**BCA & DDA/ACCESS ASSESSMENT REPORT**  
*Design Development Report*

**PROJECT:**  
**GUNNEDAH HOSPITAL REDEVELOPMENT**  
*Stage 1*

Date: 9 June 2023

Figure 3

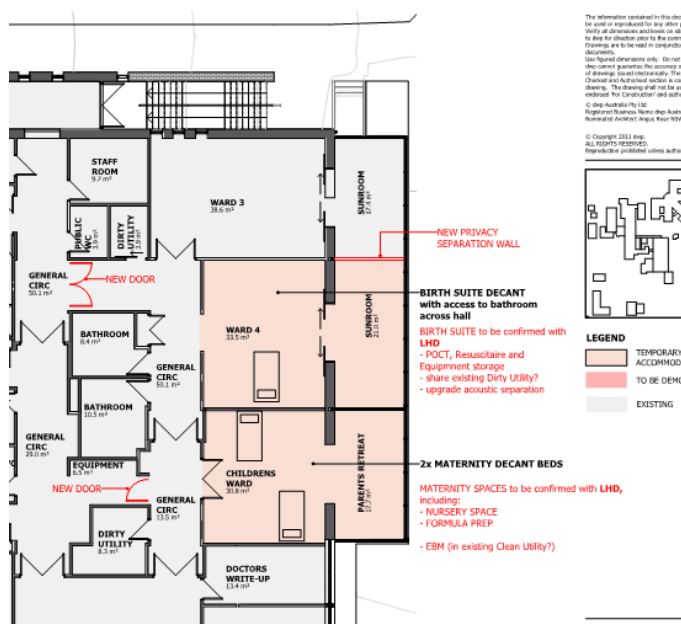
The new scope proposes to locate new birthing suite (treatment) within existing ward area. This would constitute heavy/medium refurbishment within the upgrade strategy. Noting the space is for temporary decant purposes only HI to provide confirmation sprinkler are not required within the space in line with DGN. Refer report for additional BCA requirements.

Figure 8

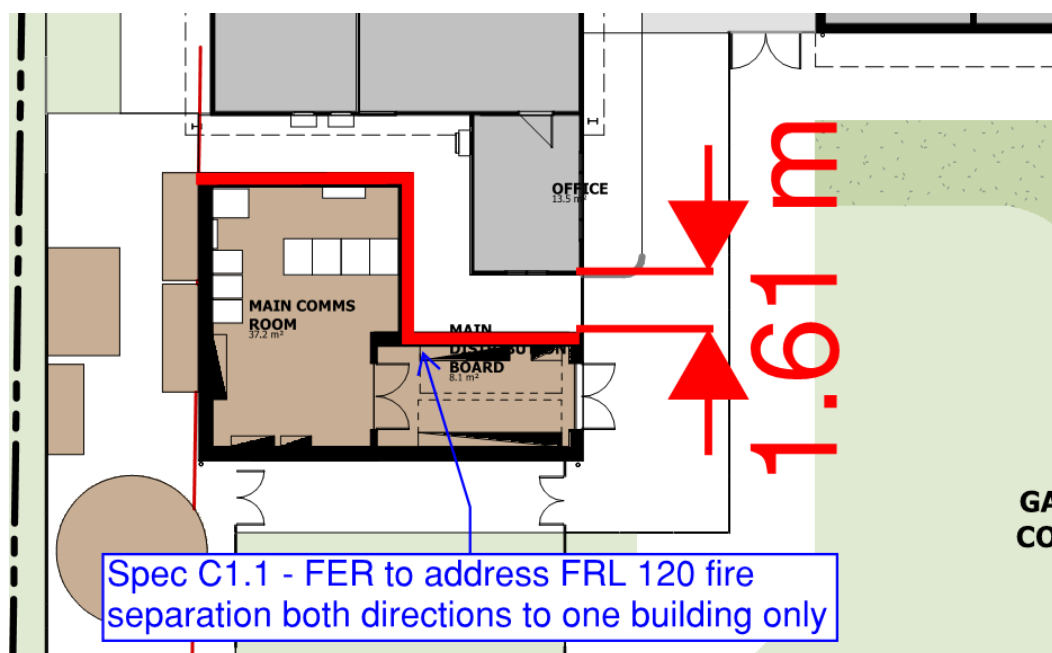
The new main comms room is <3m from the existing engineering office which is considered sperate building. The fire engineering is to permit new fire source feature located <3m from existing engineering building on basis FRL 120minute separation is achieve both directions from main comms and switch board rooms.

Figure 9

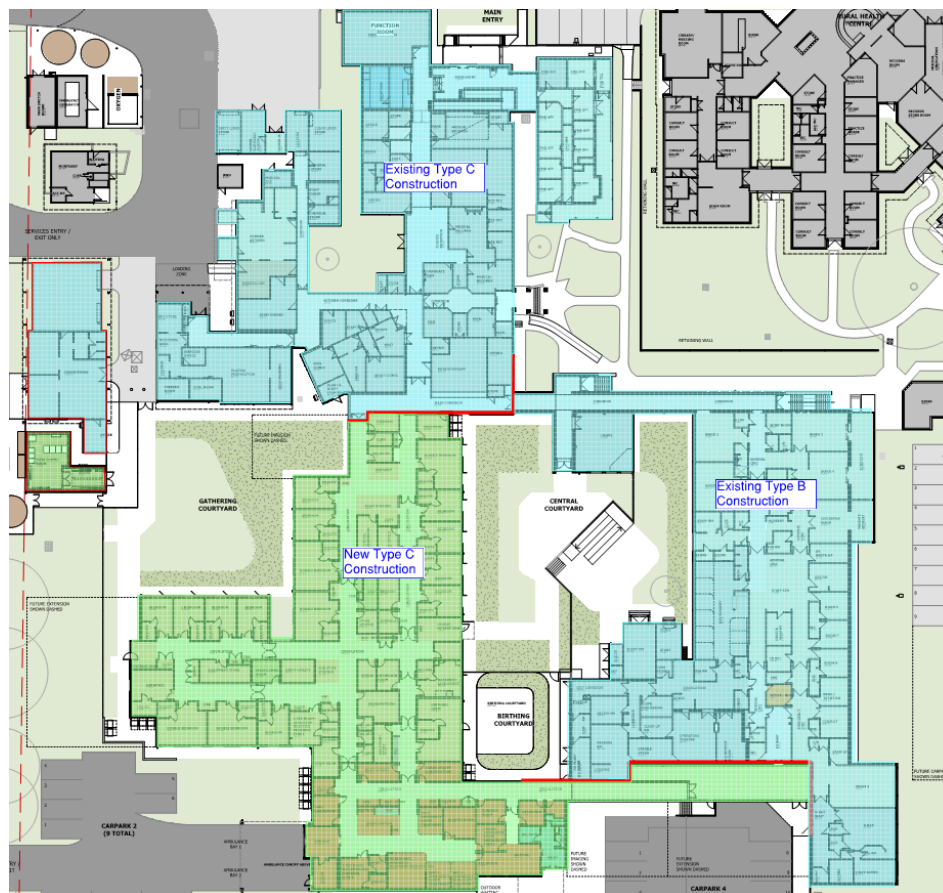
Architect required to depict FRL 120 minute separation between separate Types of Construction. Exposure between fire compartments to be addressed by way of DTS C3.3 or Performance.

Figure 10

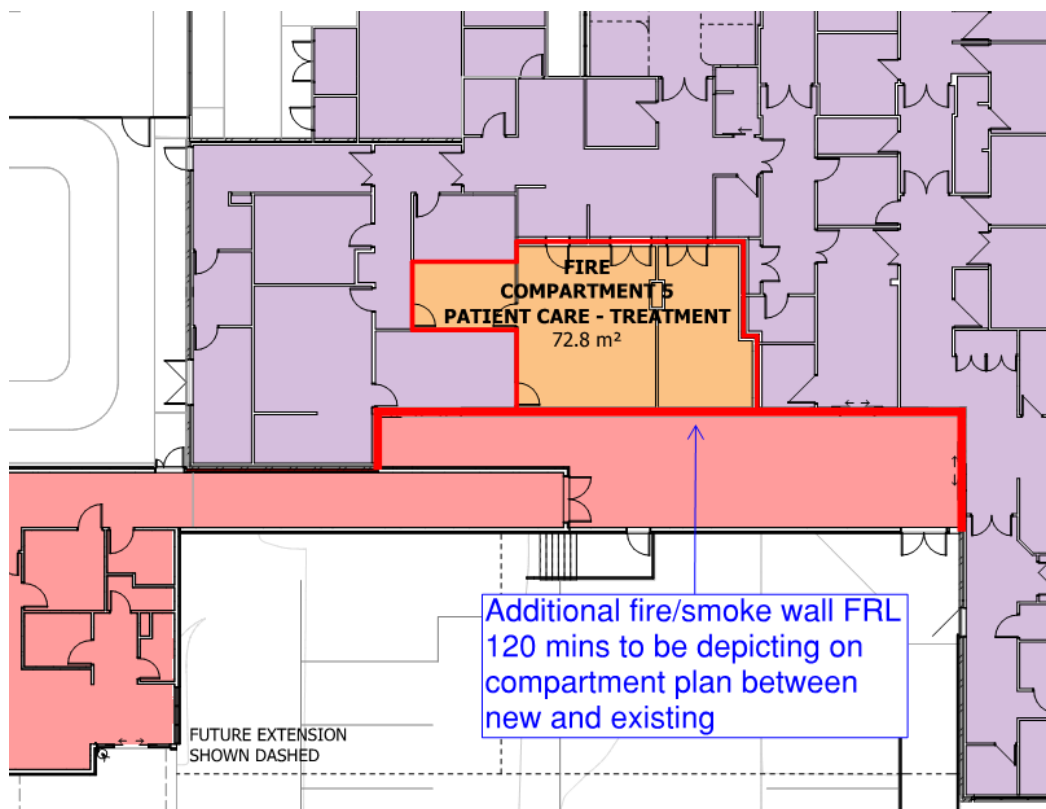
Additional fire separation required to be developed into design / depicting fire smoke separation FRL 120 mins between new (Type C) and existing (Type B) and also sprinkler to non sprinkler protected area as listed below. See C3.3 and D.12 for exposure between fire compartments and sliding doors not permitted in fire walls.

Figure 13

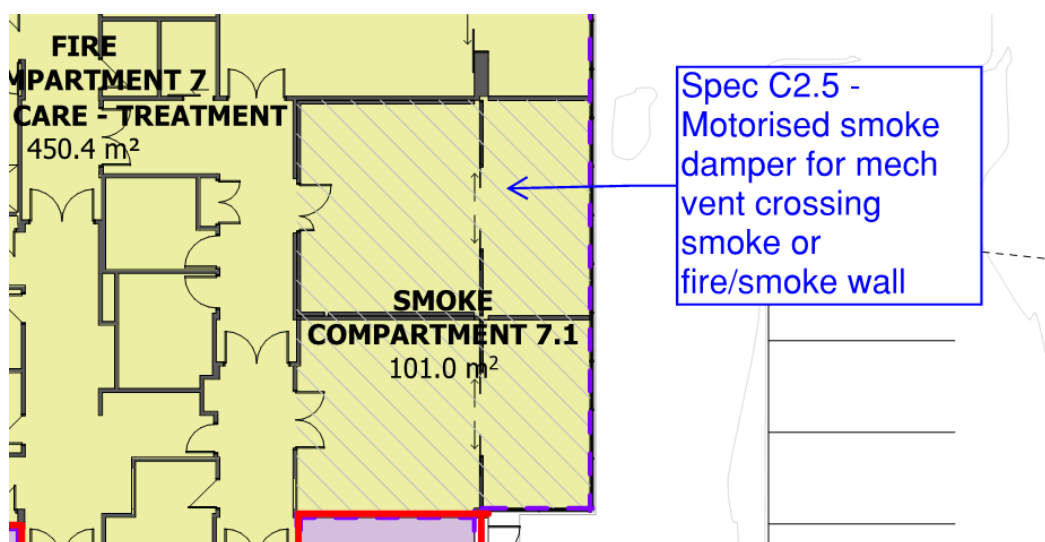
Fire smoke / dampers are required for all mechanical duct penetrations through fire/smoke walls. Smoke dampers where mechanical ductwork penetrates smoke walls. Mech engineer to confirm throughout.

Figure 14

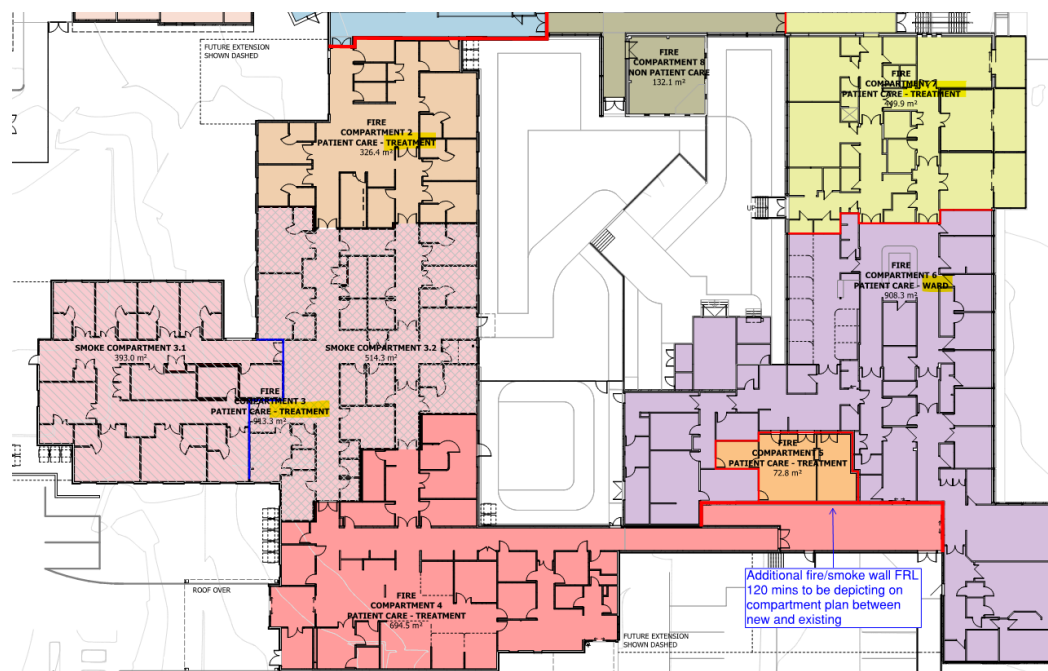
A number of compartments have ward/ treatment use incorrectly labelled as per previous editions or non-compliant compartment sizes. Fire compartment 7 is an existing ward however plans list as treatment. Fire compartment 6 is depicted as 909m2 ward which does not comply with BCA C2.5, previous plans listed as treatment. Client to confirm use of compartments and where existing use is to be retained architect to update plans accordingly.

Figure 18

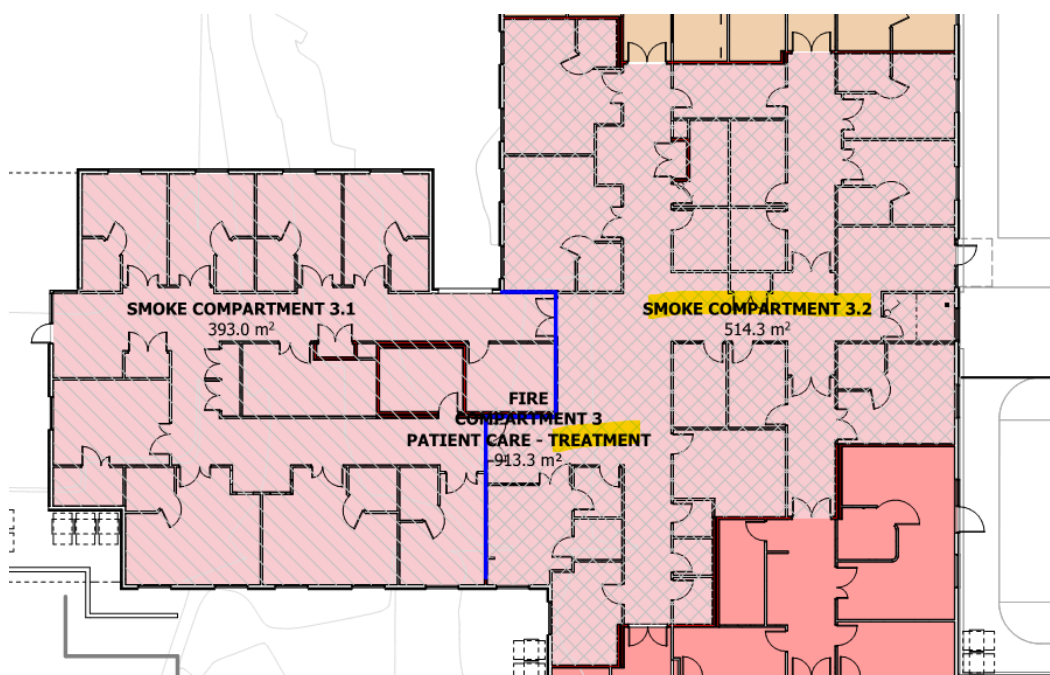
Smoke compartment 3.2 is understood to be ward and incorrectly labelled on compartment plan requiring update. The fire engineered strategy is to address max smoke compartment up to 520m<sup>2</sup> in lieu of 500m<sup>2</sup>.

**Figure 20**

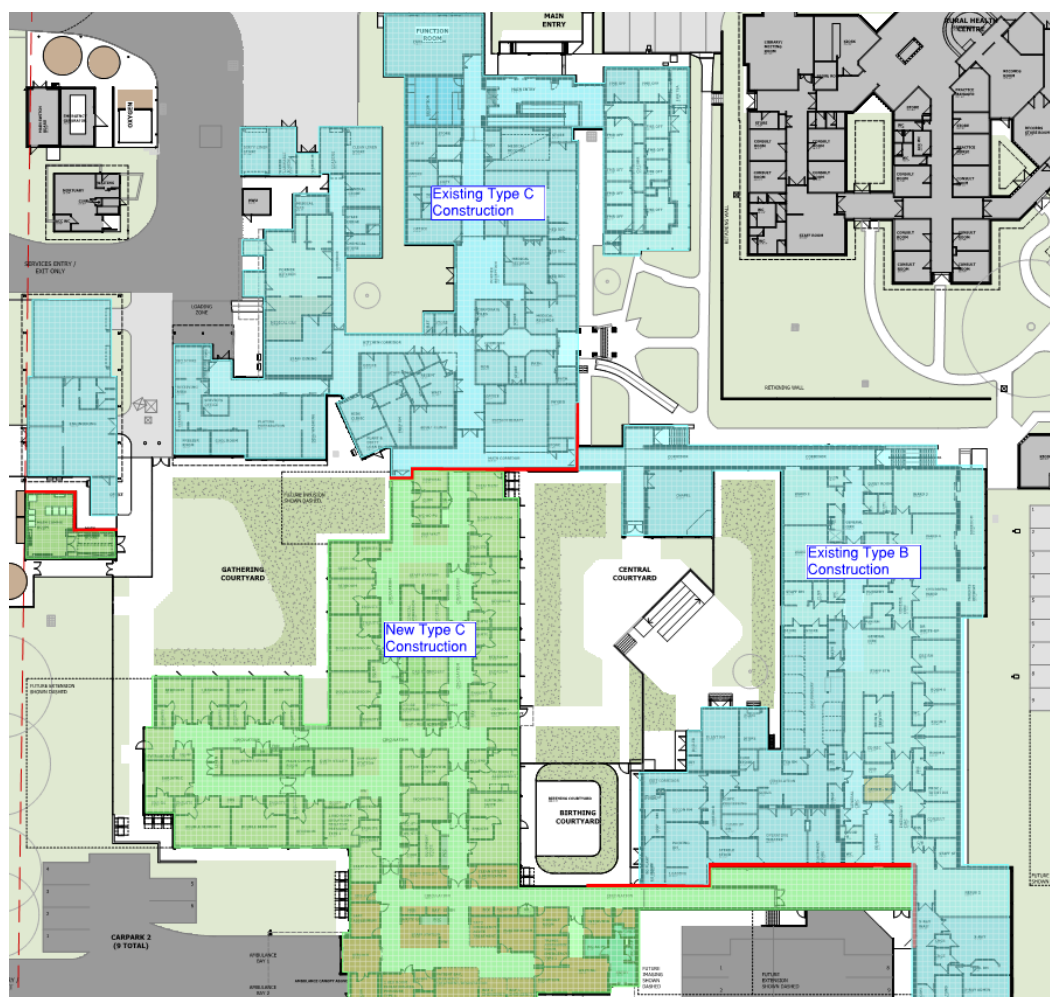
Indicative lines of separation have been depicted below to be developed into the design.

Figure 21

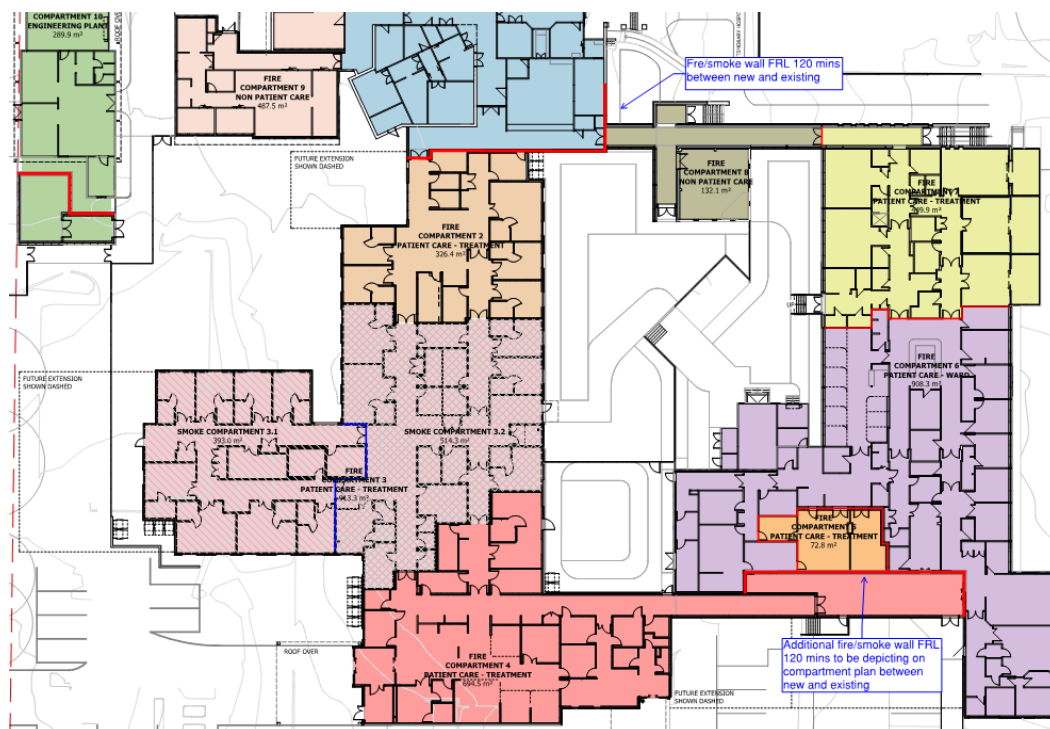
Lines of separation have been identified on DD plans are to be finalised as part of the design development. Additional fire walls are to be depicted on updated plans as shown below. Existing fire walls shall not be relied on for any new scoped area noting site inspection concluded numerous compliance concerns.

Figure 22

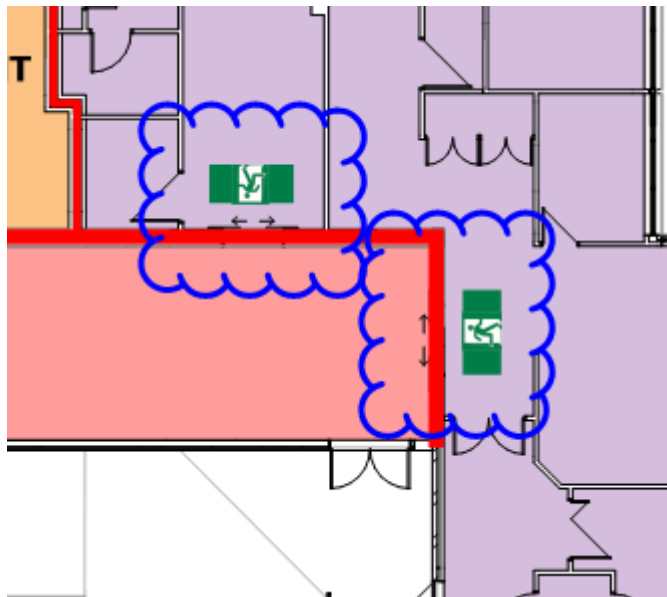
Note sliding doors are not permitted in C2.7 fire wall separating different types of construction and are required to be amended to swinging fire/smoke doors (see D2.19 also).

*Figure 23*

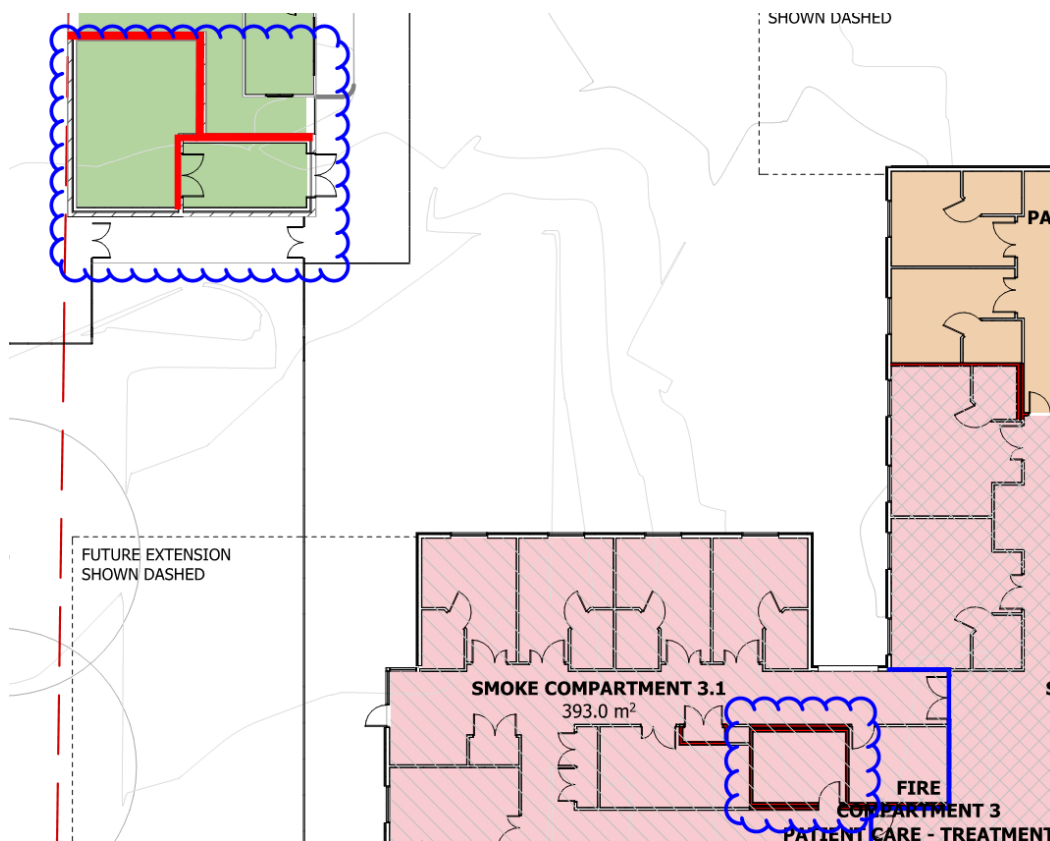
Indicative fire separation in areas is proposed. Architect to note any other spaces on plan requiring separation to BCA C2.12 or C2.13 and ensure compliance in this regard for above listed items.

Figure 26

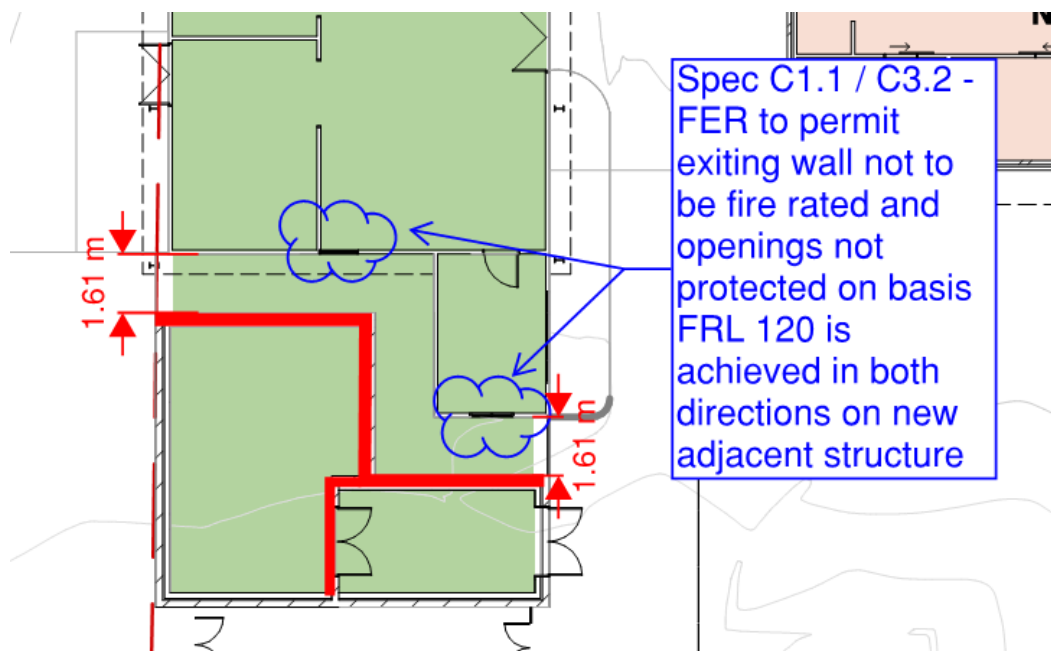
The location of new main comms room and DB boards creates non compliance for existing maintenance engineering building in regards to external wall for fire rated and openings not protected. The FER is to address on basis FRL 120 minute separation in both directions is achieved in adjoining building.

Figure 28

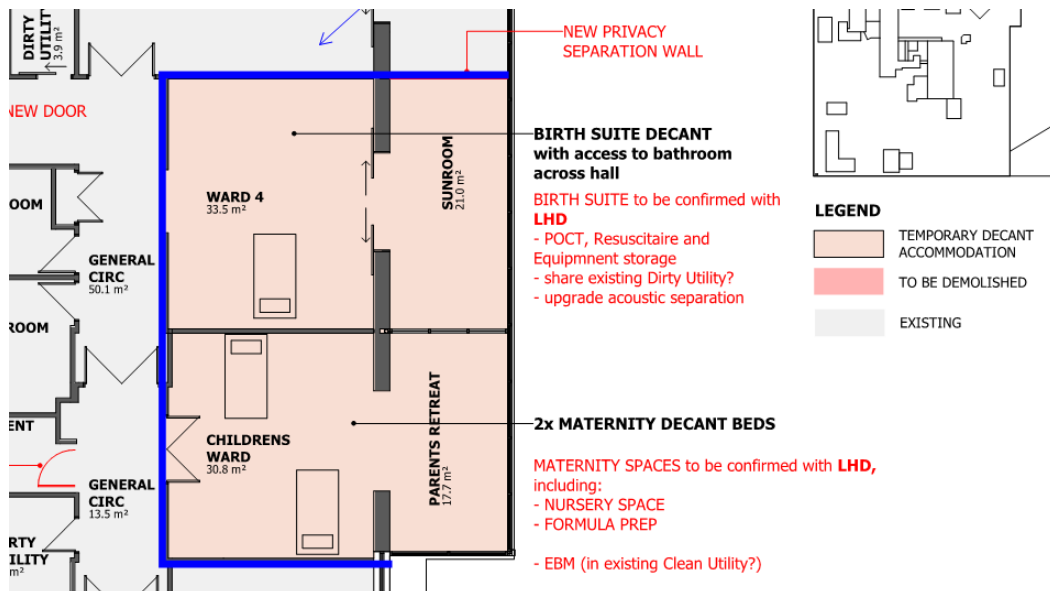
Location of temporary birthing suite (treatment) within existing ward area requires the exposure between fire compartments to be addressed by way of DTS or FER. Confirmation is required how compliance will be achieved.

Figure 30

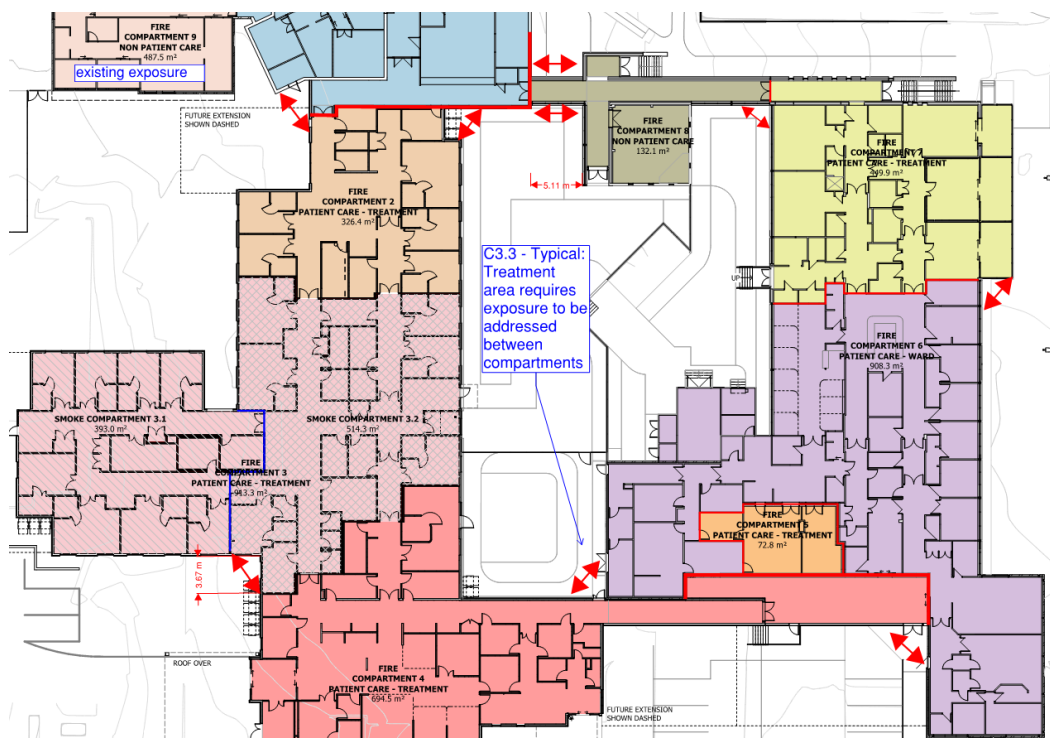
Red arrows indicate areas requiring further design development or rationalisation are as shown below.

Final compartment plan to be provided for review and consideration of inclusion by way of Fire engineered strategy where FRL 120 minute wall on one side of fire compartment is proposed in lieu of DtS both sides.

Figure 31

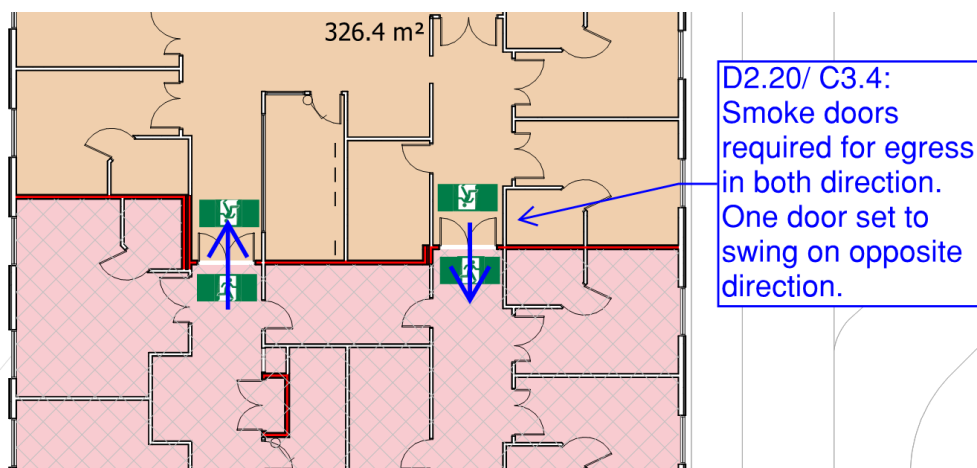
Typical example below where fire/smoke doors required in both direction and swing against egress to be addressed in FER. Not in scenarios such as below where two door sets required one shall swing the opposite to the other.
